ADDENDUM NO. 1 – OCTOBER 9, 2015

**TOWN OF LINCOLN
Bemis Hall Basement Renovations
Lincoln, MA
Plans and Specifications
Prepared by Abacus Architects + Planners**

1 BASEMENT FIRE ALARM PLAN
 E 102 SCALE: 1/4" = 1'-0"

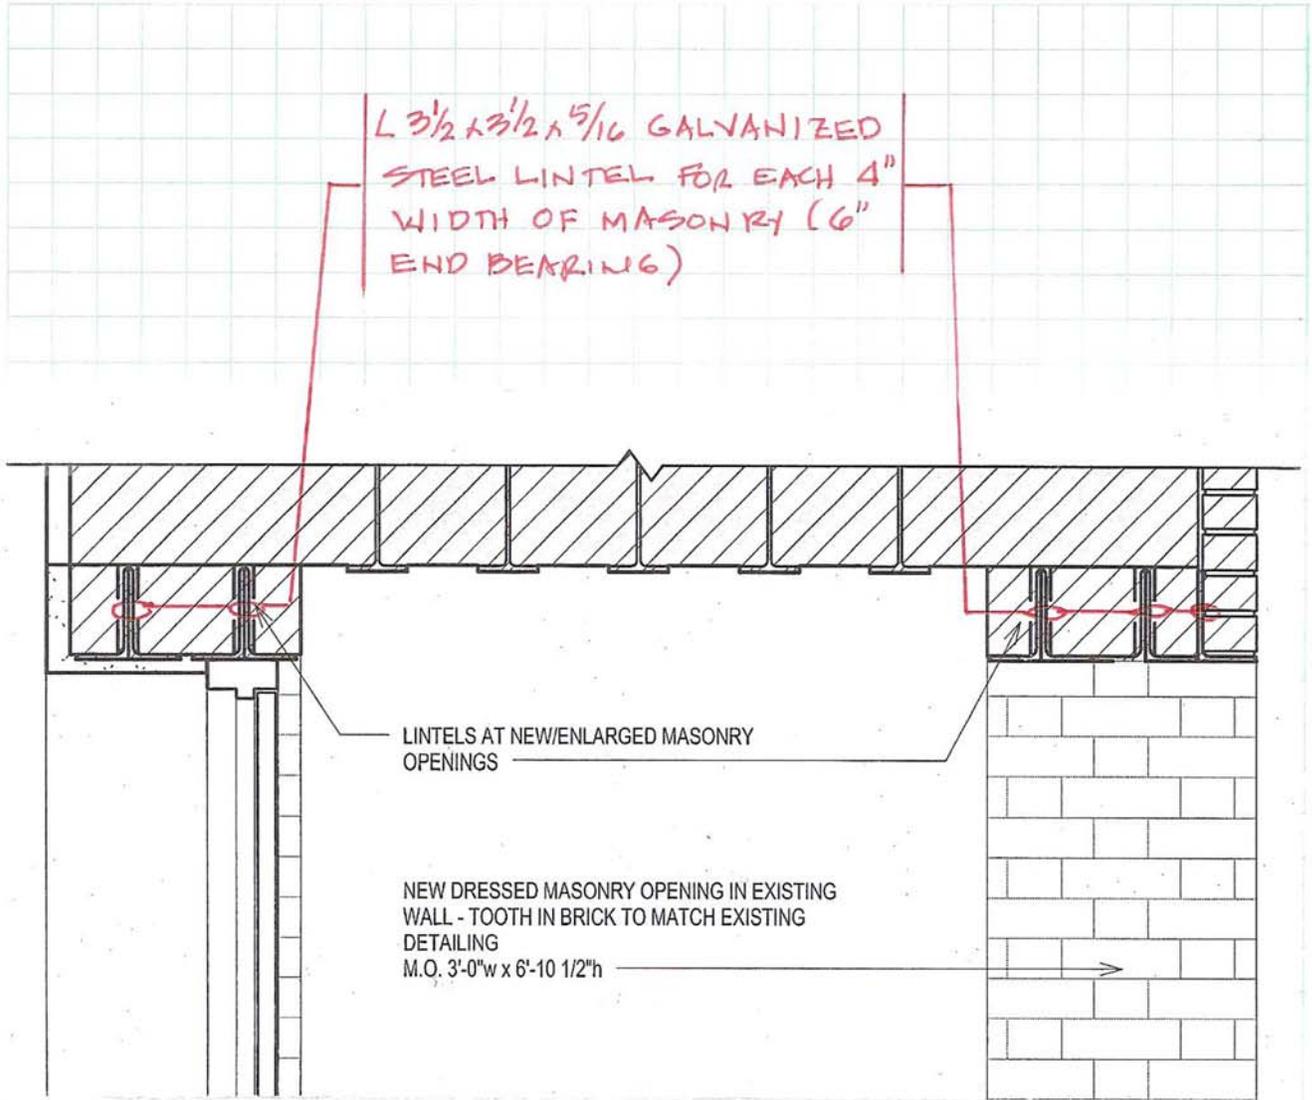
1. Is the CO detector part of the fire alarm system or 120 volts.
2. Please clarify on Dwg "E102" which devices are New and which are existing. Is it safe to assume unless specifically Tagged as "New" all others are "" "ETR"-Existing to remain"". It is hard to decipher because some are in "Bold", but not tagged as "New". For example in room "Office #1 Symbol (SD) in a circle bolded, but does not have a tag as "New" Also some rooms such as "Office #1" have Note number 1, Which states that FA in that room is existing to remain, yet show a Heat Detector NOT Bolded and the (SD) Bolded. So it could be interpreted differently from everyone.

RESPONSE: The CO detector shown on E-102 is ETR. New devices are shown bold while ETR devices are shown light. Not all new devices are identified as new. The entire drawing sheet E-102 has been “reprinted” so that the bold devices are more distinctly bold and that sheet is attached to this Addendum #1.

PARTIAL SECTION 4 ON DRAWING A302
SHOWING LINTEL SIZES 1" = 1'-0" ±

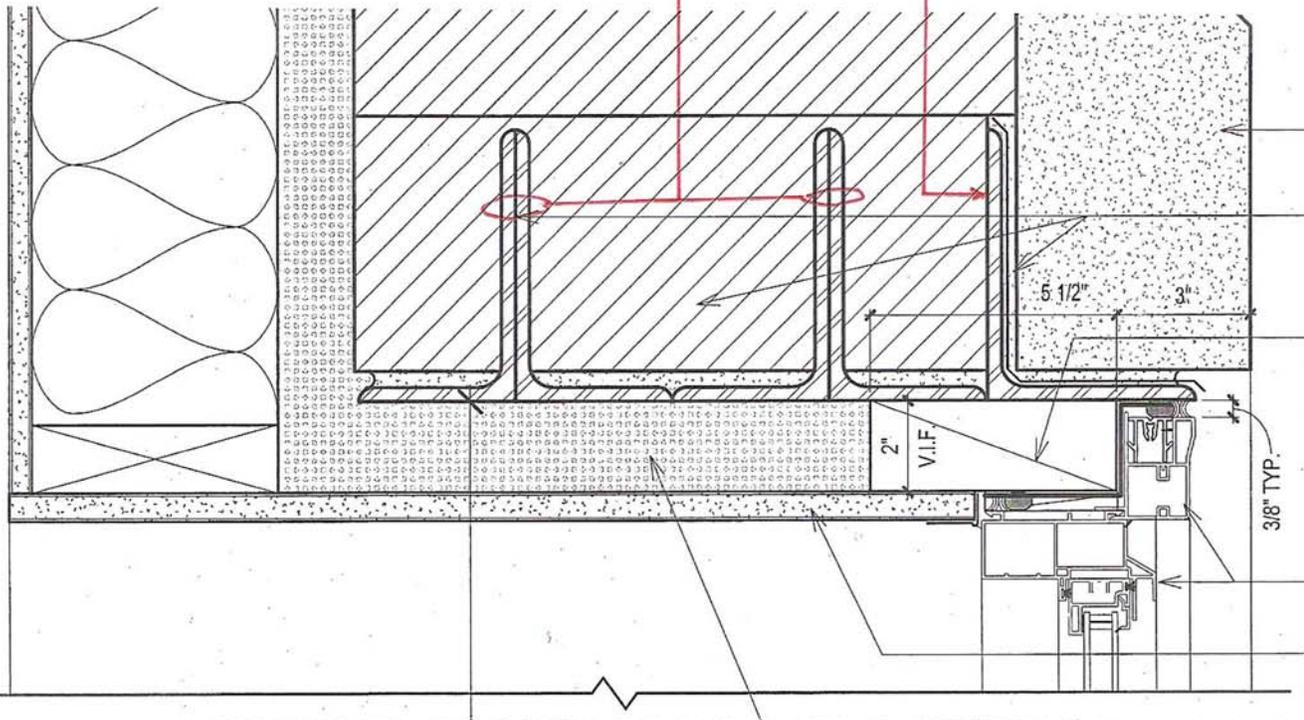
L6x3½x 5/16 GALVANIZED
STEEL LINTEL (6" LEG
VERTICAL) FOR EACH 4"
WIDTH OF MASONRY
(8" END BEARING)

L6x4x 5/16 GALVANIZED
STEEL LINTEL (6" LEG
VERTICAL) UNDER
GRANITE COURSE.
(8" END BEARING)

PARTIAL DETAIL 1 ON DRAWING A501
SHOWING LINTEL SIZES 3" = 1'-0" ±

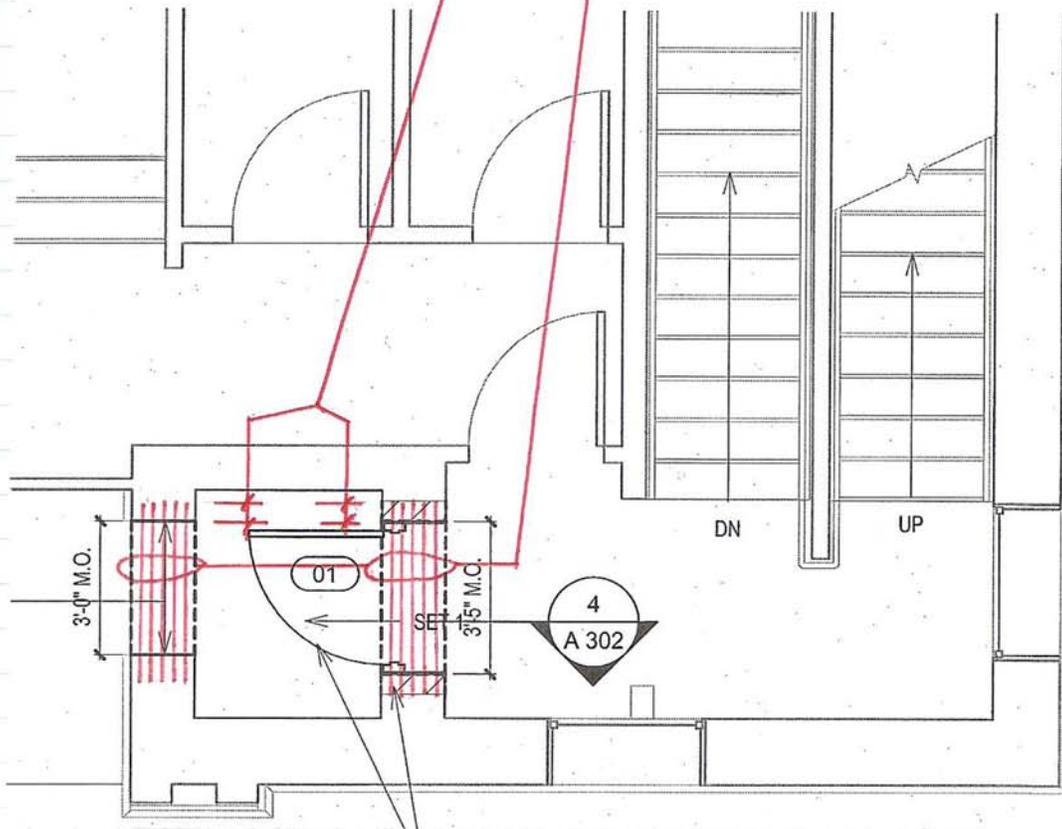
PROVIDE 6" OF BEARING
LENGTH ON SOUND MASONRY
AT EACH END OF EACH
LINTEL (TYP.)

L 3 1/2 x 3 1/2 x 5/16 GALVANIZED
STEEL LINTEL FOR EACH
4" OF MASONRY

LINTELS AT FIRST FLOOR EGRESS DOOR 1/4" = 1'-0" ±
(REFER TO PLAN #2 ON DRAWING A101)

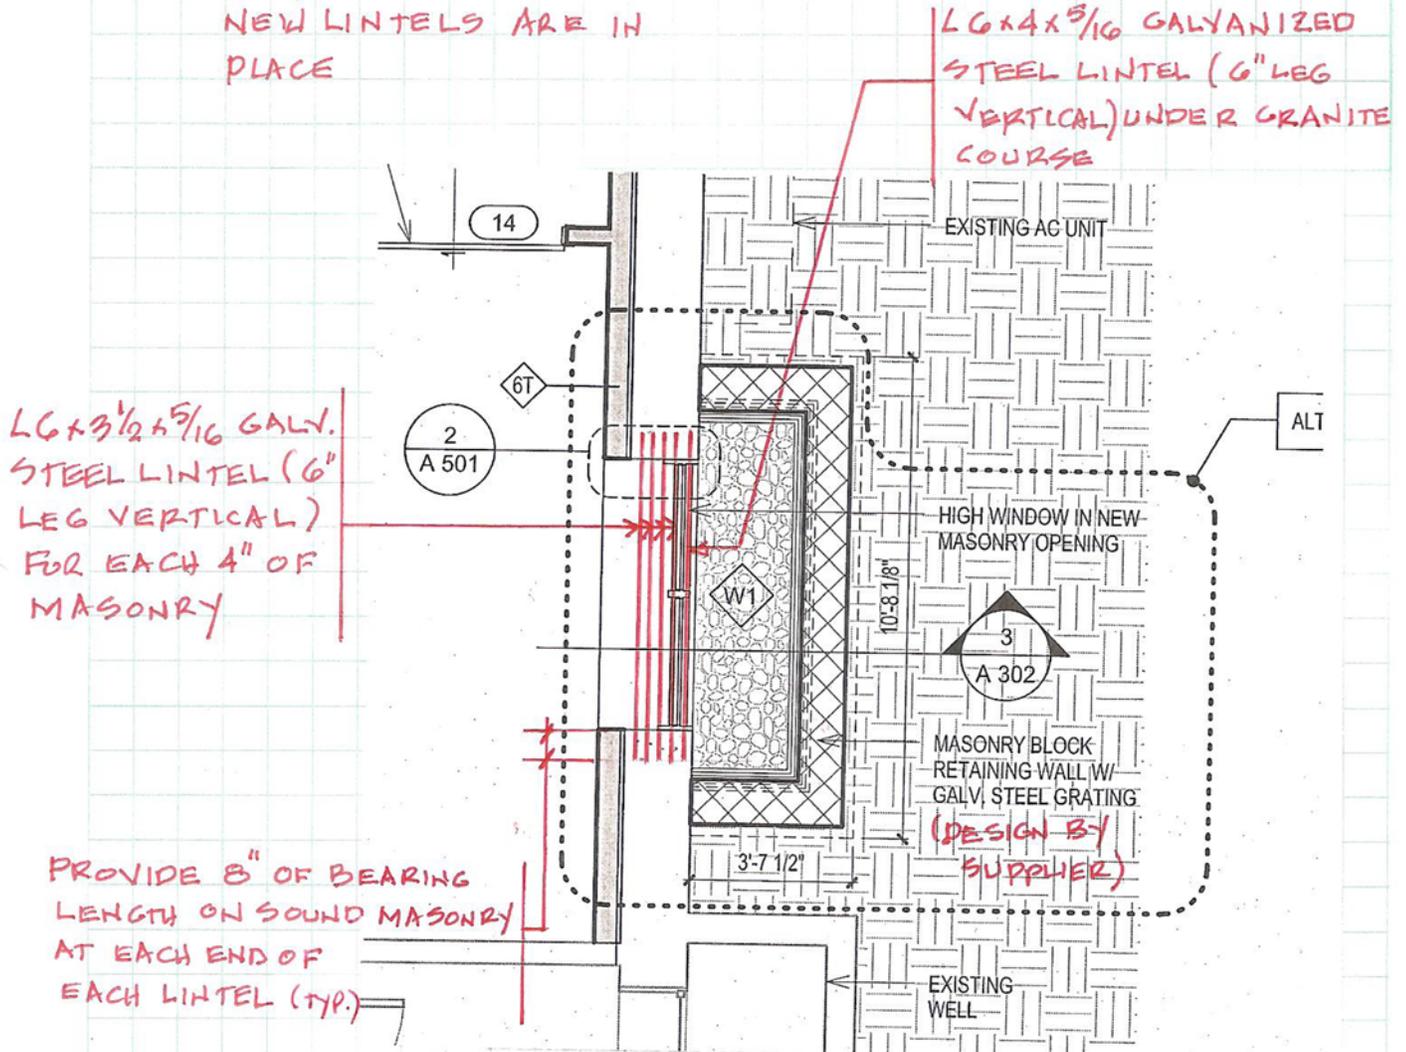
NOTE: PROVIDE ALL NECESSARY
TEMPORARY SHORING UNTIL
NEW LINTELS ARE IN
PLACE

LINTELS AT WINDOW TYPE W1 '4" = 1'-0" ±
PLAN #1 ON DRAWING A101)

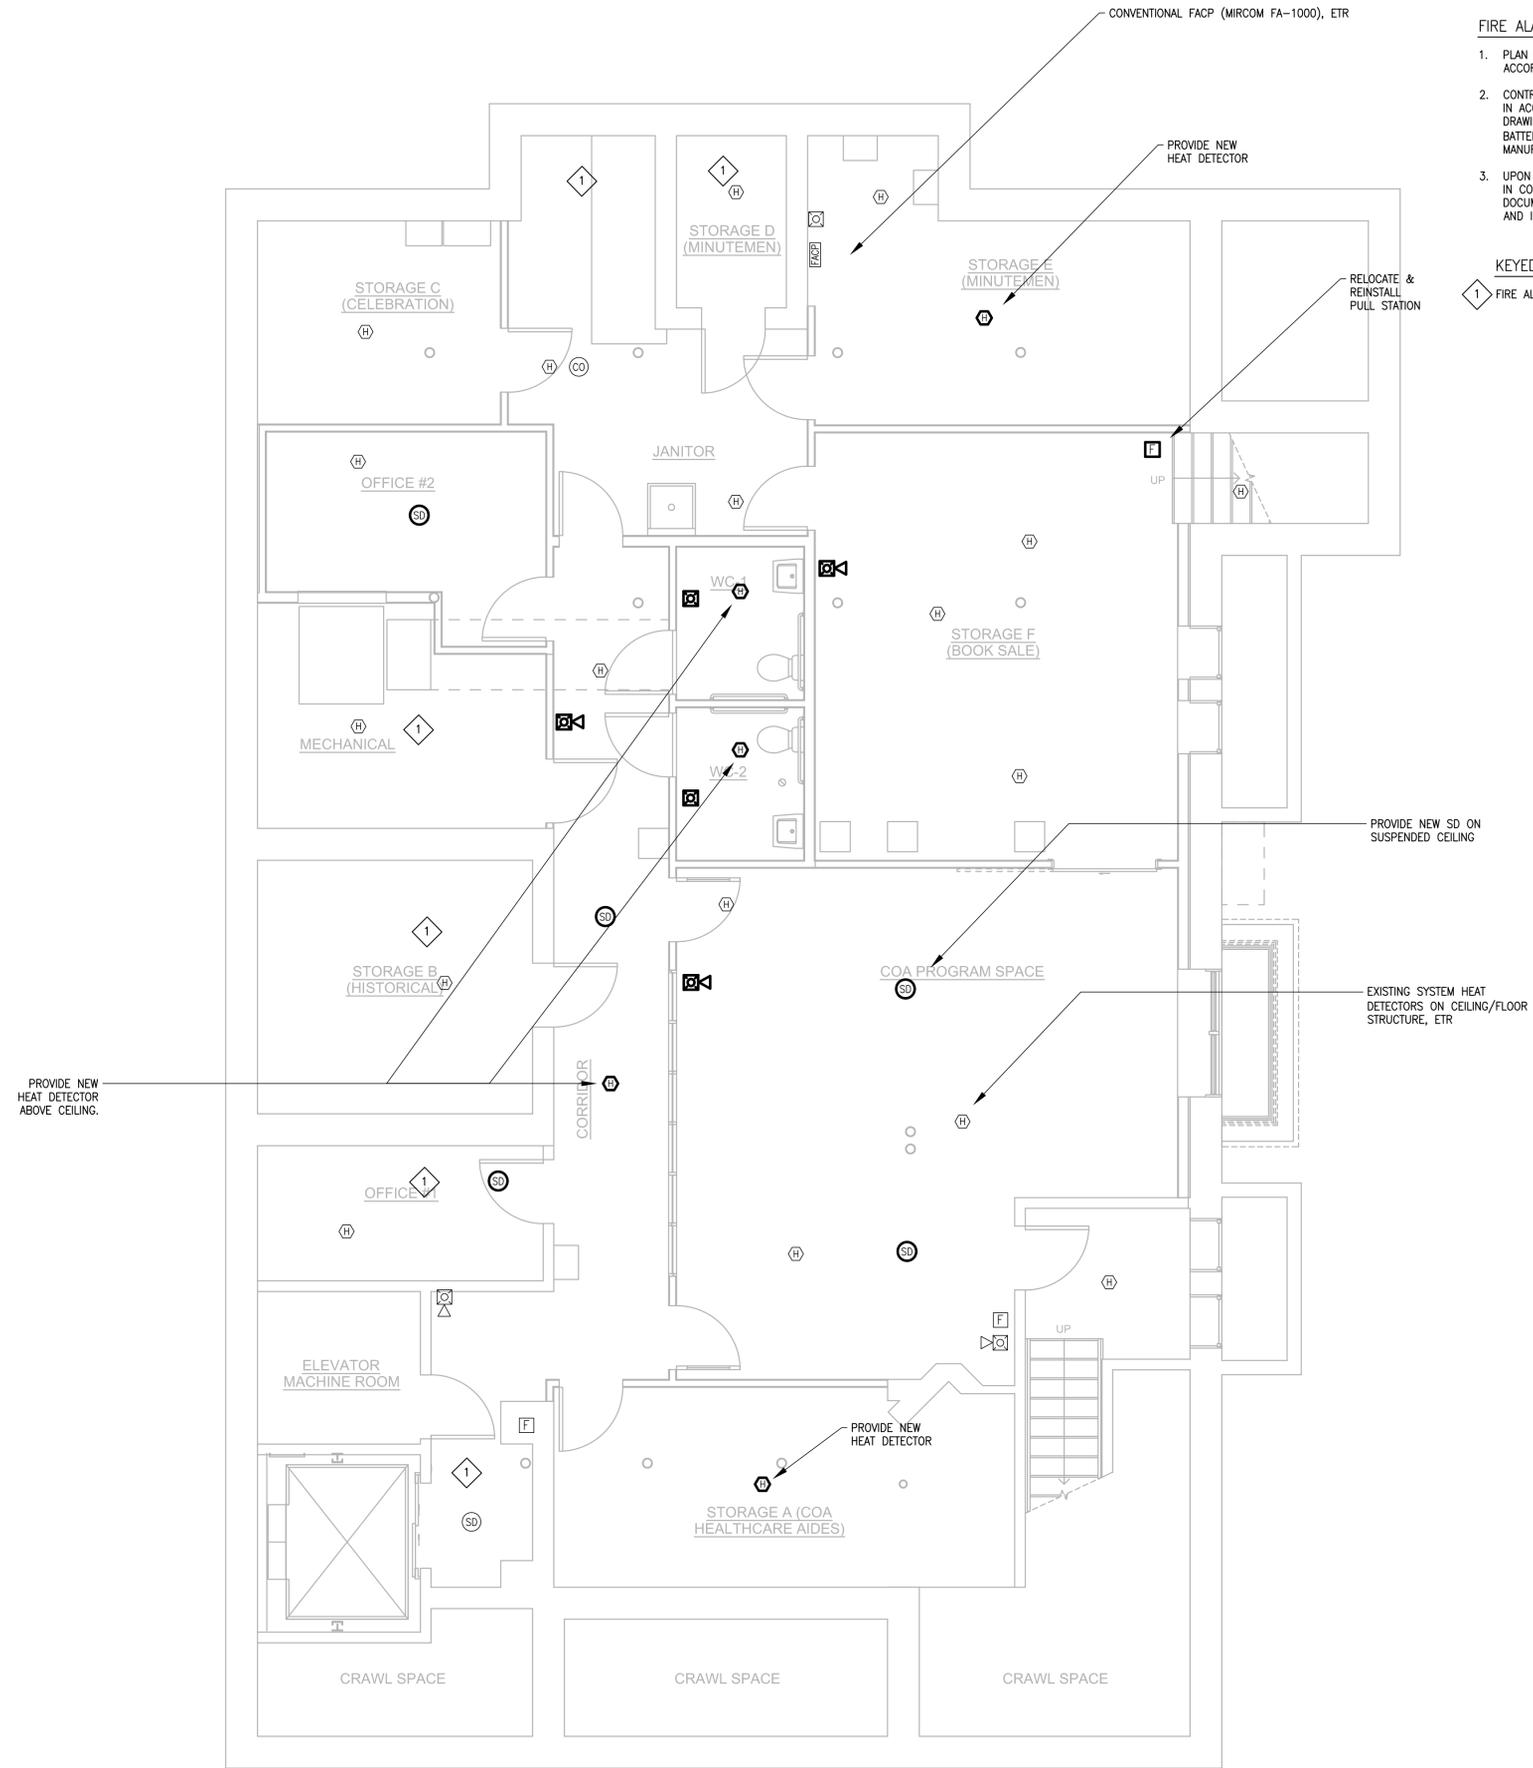
NOTE: PROVIDE ALL NECESSARY
TEMPORARY SHORING UNTIL
NEW LINTELS ARE IN
PLACE
